Planning Commission Staff Report

Project Type: Residential Addition

Description: 18047 Wild Horse Creek Rd (Corey and Lisa Meyer): A request for a residential

WEST ELEVATION

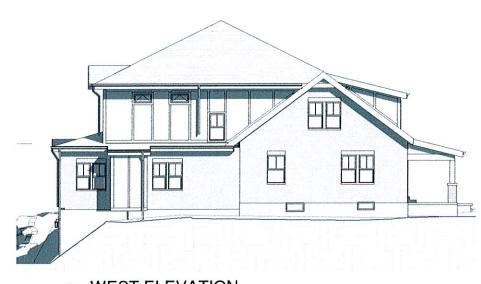
- Primary building material shall be extended and installed so that no more than twelve (12) inches
 of concrete foundation wall is exposed
 - Generally, the architectural elevations provided indicate that this requirement will be met, with the exception of the west elevation. The property owners have been notified of this requirement. All Municipal Zoning Approval applications for construction of new residences or additions are conditioned with this requirement, and inspections to verify compliance are conducted prior to issuance of the Occupancy Permit for the structure.
